1 **Comment #55, #56, #57, #63, #70, #104, #105, #106, #107, #117, #120, #121, #122, #126, #128, #326, #327, #399,**  
2 **(TDL #268, #269, #358, #143 from D2.2)**  
3

4 Single-signature DLL state machines:

43  
44 **Proposed Remedy:**

Figure 145–43—PSE power control state diagram

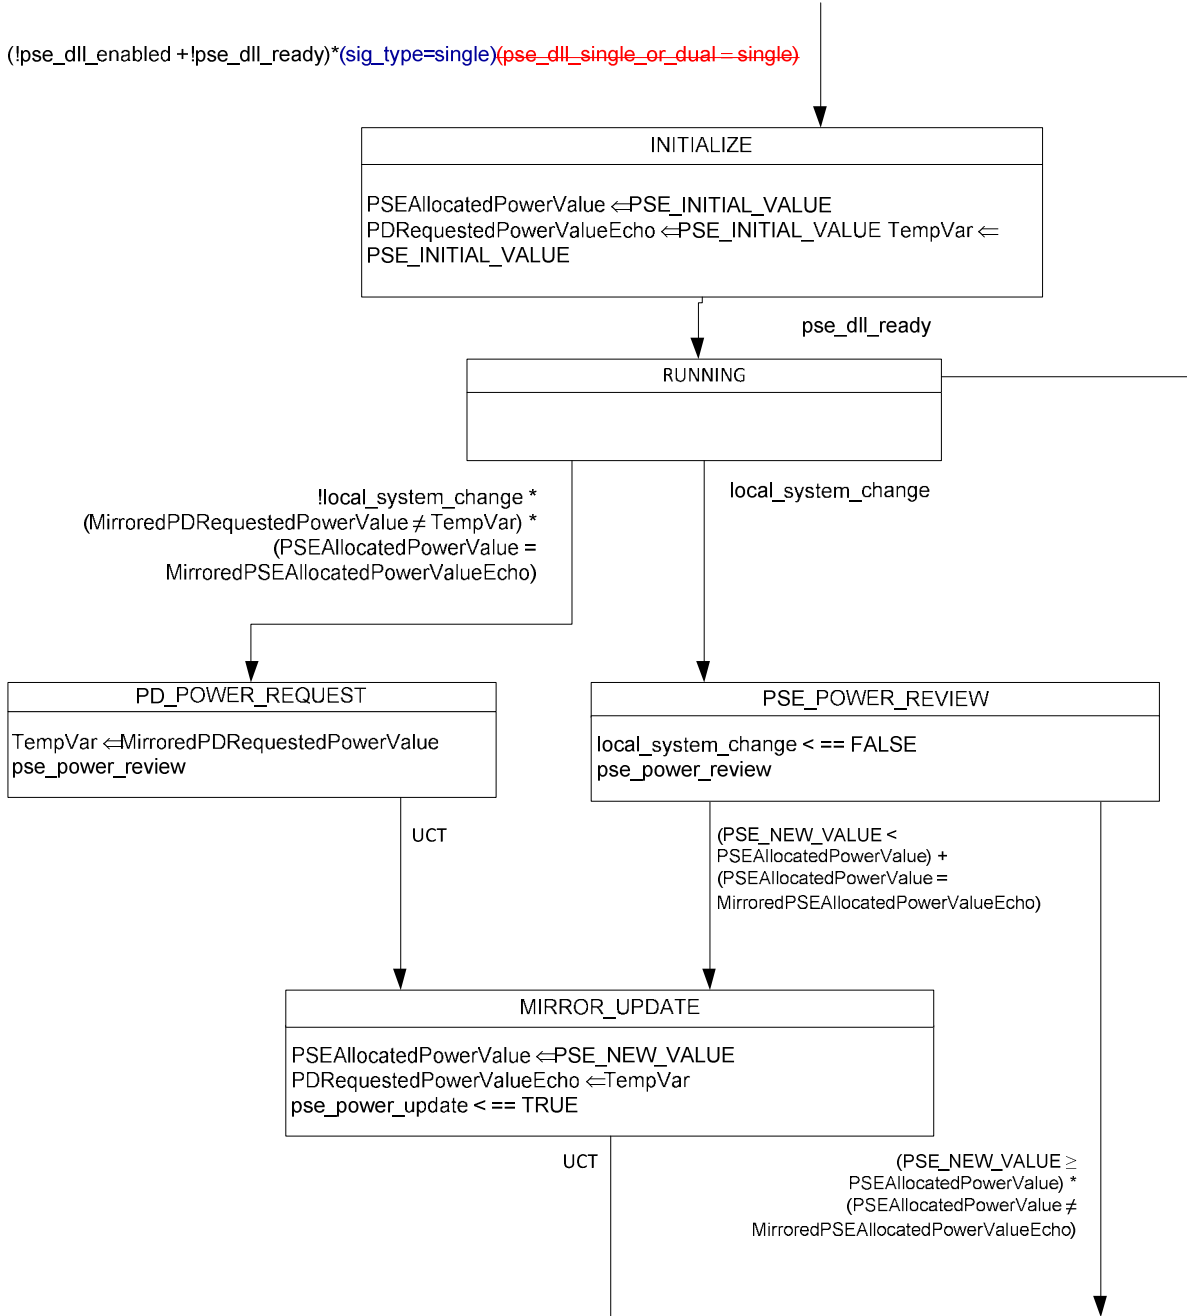
- 7 2. From comment #167 D2.2, the assignment 'pse\_dll\_power\_type <= pse\_power\_type' in the INITIALIZE state is not required  
8 (Figure 145-43, PSE DLL state machine) and was already implemented in D2.3. Removing it also from Table 145-39.

- 9 3. Removing pse\_dll\_power\_type from the variable list. It is not used by the state machines Figures 145-43 and Figure 145-44.
- 10 4. Removing pse\_power\_type from the variable list. It is not used by the state machines Figures 145-43 and Figure 145-44.

- 13 6. pse\_dll\_single\_or\_dual was replaced with the variable sig\_type which already exists and generated but the connection check  
14 function. It is needed for PSE DLL state machine only.

117 **145.5.3.6 State diagrams**  
 118 The general state change procedure for PSEs is shown in Figure 145–43.  
 119 **Make the following changes in Figure 145-43:**  
 120

Figure 145-44—PD power control state diagram

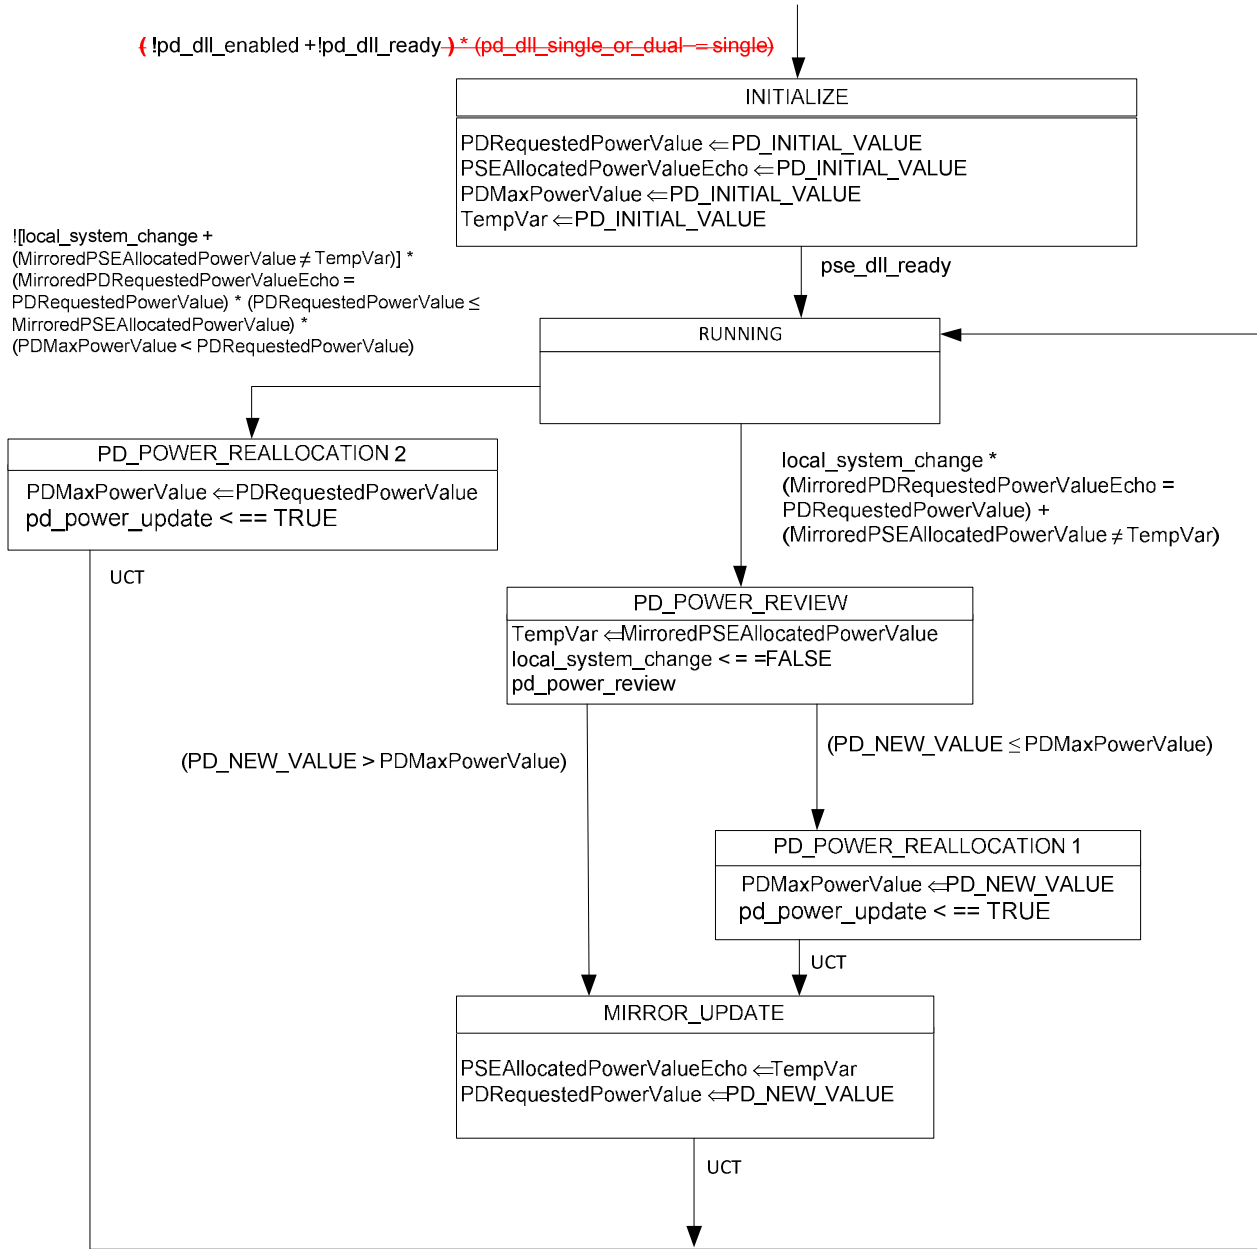
- 5 1. From comment #155 D2.2, the assignment 'pd\_dll\_power\_type <= parameter\_type' in the INITIALIZE state is not required  
6 (Figure 145-44, PD DLL state machine) and was already implemented in D2.3. Removing it also from Table 145-39.

- 11 5. pd\_dll\_single\_or\_dual was removed the entire draft due to the following reasons: (a) PD knows if it is a single-signature or  
12 dual-signature. (b) This information is in the TLVs fields anyway. As a result PD will use the correct DLL state machine.

126 Make the following changes in Figure 145-44:

Figure 145-47—PSE power control state diagram Alternative (X) when connected to a dual-signature PD mode (X)

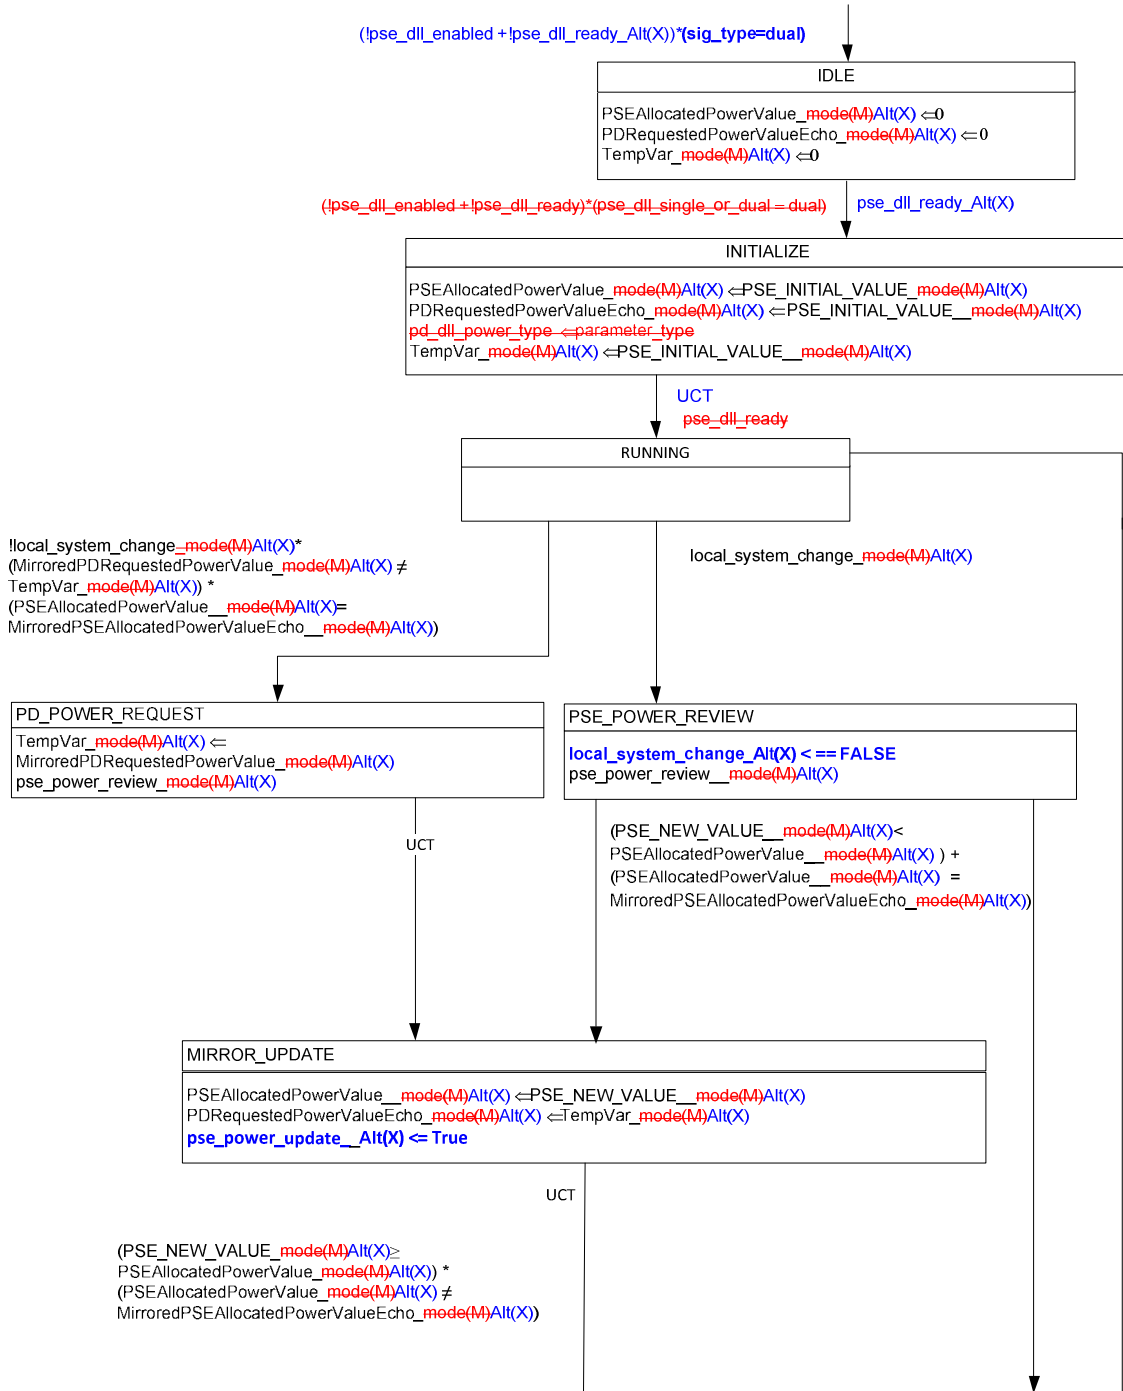
- 27 11. From comment #167 D2.2, the assignment 'pse\_dll\_power\_type <= pse\_power\_type' in the INITIALIZE state is not required  
28 (Figure 145-47, PSE DLL state machine). Removing pse\_dll\_power\_type from the variable list. It is not used by the state  
29 machines Figures 145-47 and Figure 145-48.

- 33 13. Removing the variables pd\_dll\_power\_type and pse\_dll\_power\_types from Table 145-40.
  - 34 14. In PSE\_POWER\_REVIEW state, the local\_system\_change\_Alt~~(M)~~(X) was reset to prevent it from being stuck in endless loop  
35 (set to local\_system\_change\_Alt~~(M)~~(X) <= FALSE). This is done according to Clause 21.5.2, "Once set, variables retain their  
36 values as long as succeeding blocks contain no references to them." As a result, we need to explicitly change it in the state  
37 when needed. Other option would be to treat the exit from RUNNING state to PSE\_POWER\_REVIEW as a triggering pulse but in this case we need to  
38 define this behavior in the local\_system\_change\_Alt~~(M)~~(X) variable definition. Same issues with the MIRROR\_UPDATE state for  
39 pse\_power\_update\_Alt~~(M)~~(X) <= True. Both methods were simulated and work. I choose the first one which is simple and covered by Clause 21.5.2.

478 *Update the following PSE state diagram Figure 145-47 per the following changes. In addition:*  
 479 *-Verify that all variable extensions are with “\_Alt(X)” only.*

Not part of the baseline  
 Before the PD is going to IDLE and its pd\_dll\_enabled\_Alt(X) became FALSE, The TLV field need to be filled with value=0. This was implemented by adding new state IDLE.

Figure 145-48—Dual-signature PD power control state diagram mode(X)

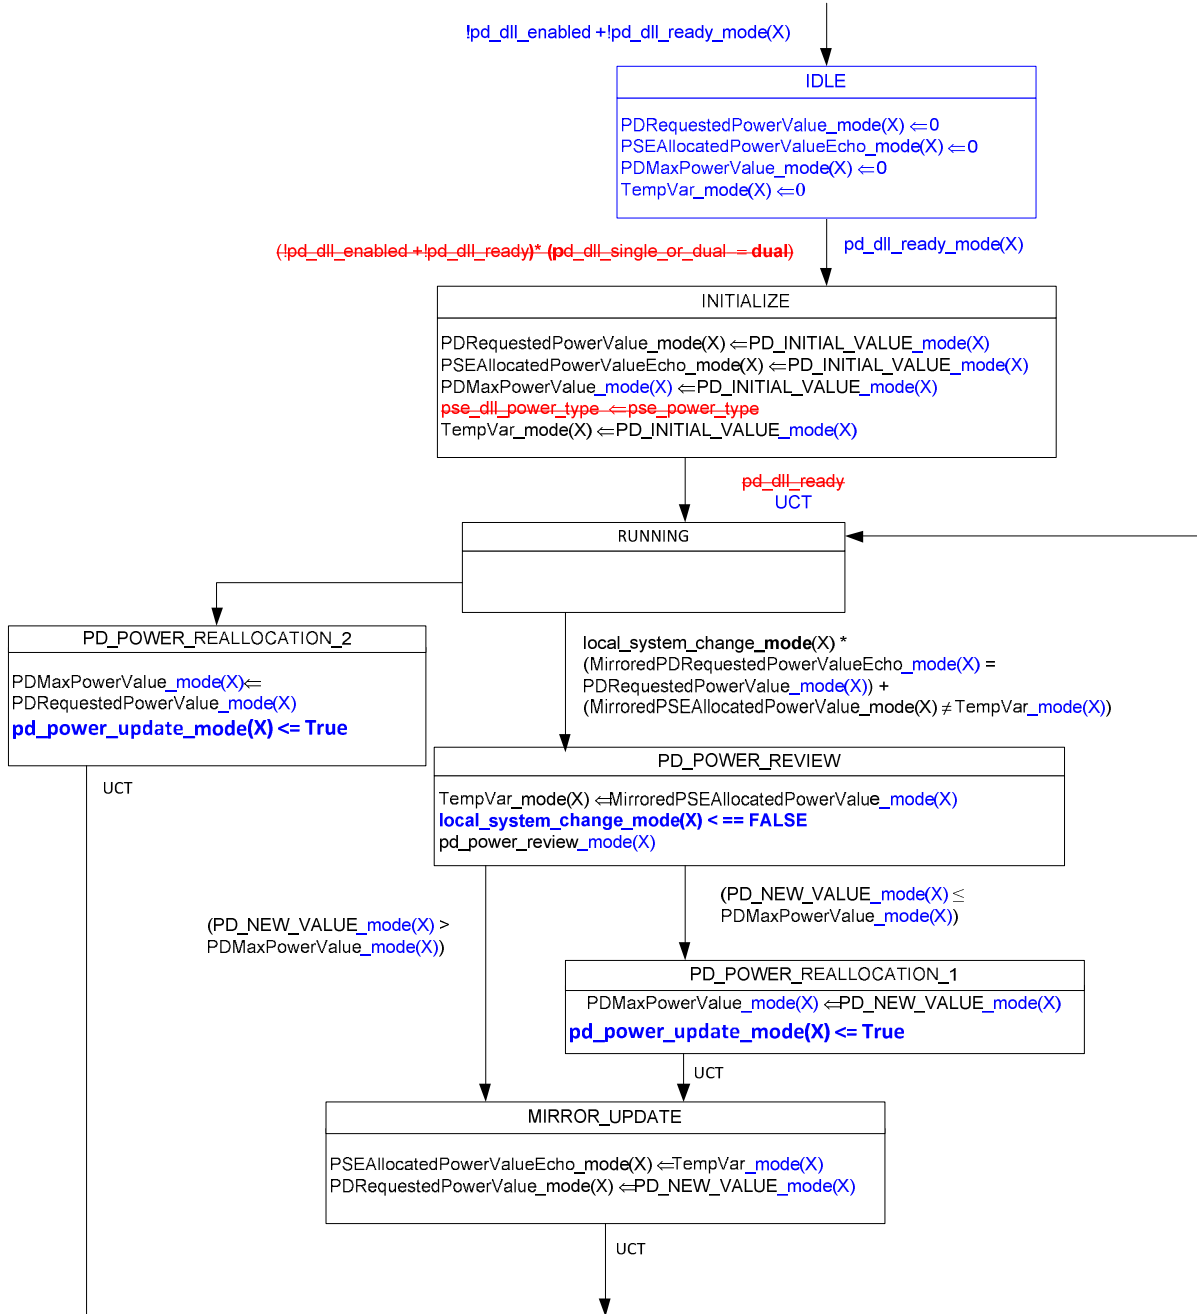
- 30 12. From comment #155 D2.2, the assignment 'pd\_dll\_power\_type <= parameter\_type' in the INITIALIZE state is not required  
31 (Figure 145-48, PD DLL state machine). Removing pse\_power\_type from the variable list. It is not used by the state machines  
32 Figures 145-47 and Figure 145-48.

485 *Update the following PSE state diagram Figure 145-48. In addition:*  
 486 *-Verify that all variable extensions are with “\_mode(X)” only.*

Before the PD is going to IDLE and its pd\_dll\_enabled\_mode(X) became FALSE, The TLV field need to be filled with value=0. This was implemented by adding new state IDLE.
